UJ Light Technologies Corporation

Product Change Notification (PCN)

Affected Model: **BC0802B/UC0802B** **Serials**

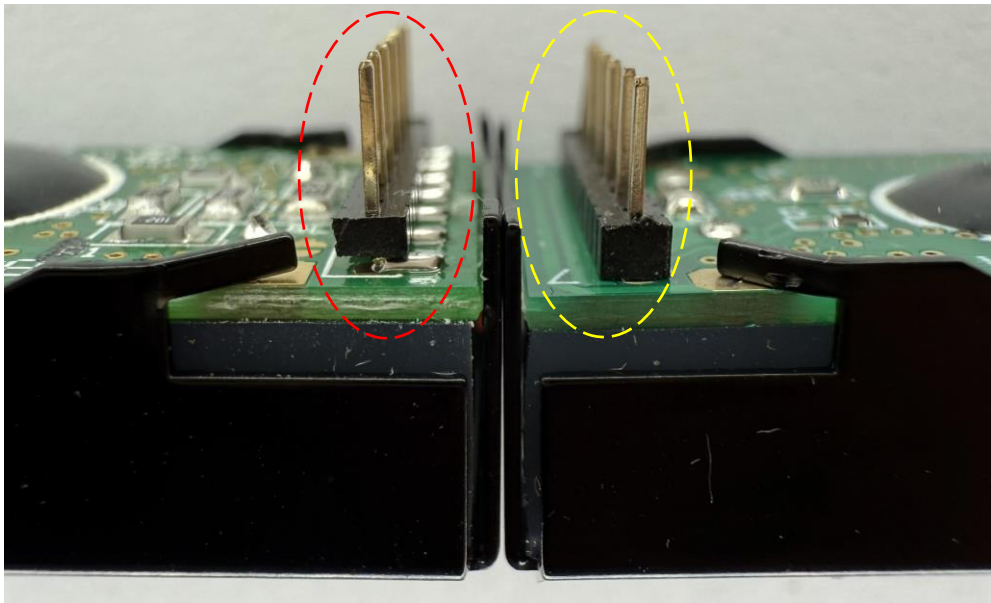
In order to improve the PIN welding positioning and working time issues of this series of products, we changed the welding method of the pin header to increase product reliability.

Before Change	After Change
90 degree pin header, difficult to position and weld	180 degree pin header, through-hole PCB, precise position

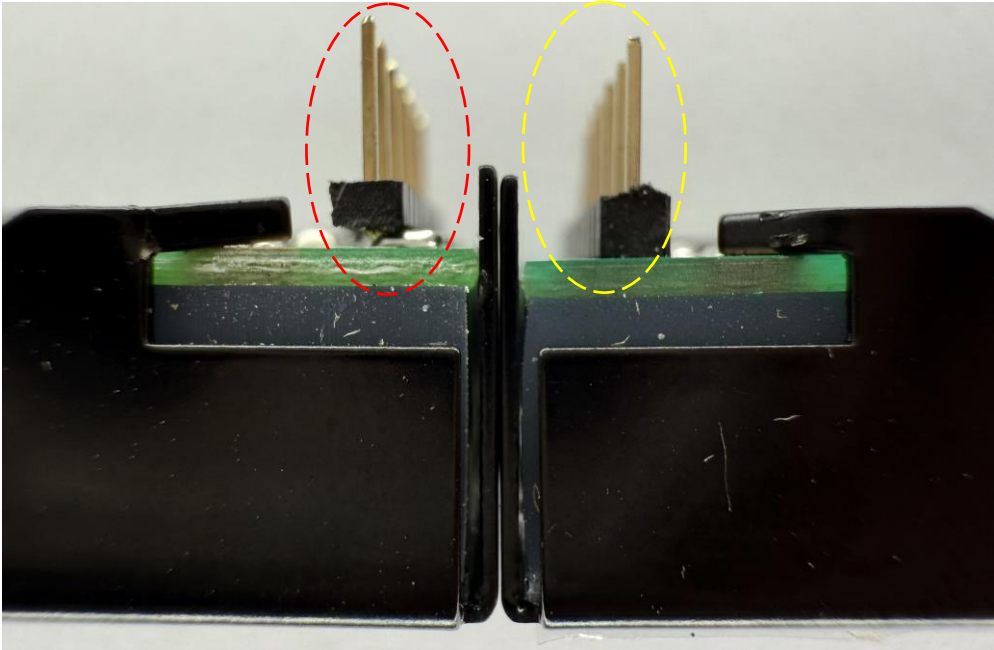
Before Change	After Change
Appearance unchanged	Appearance unchanged
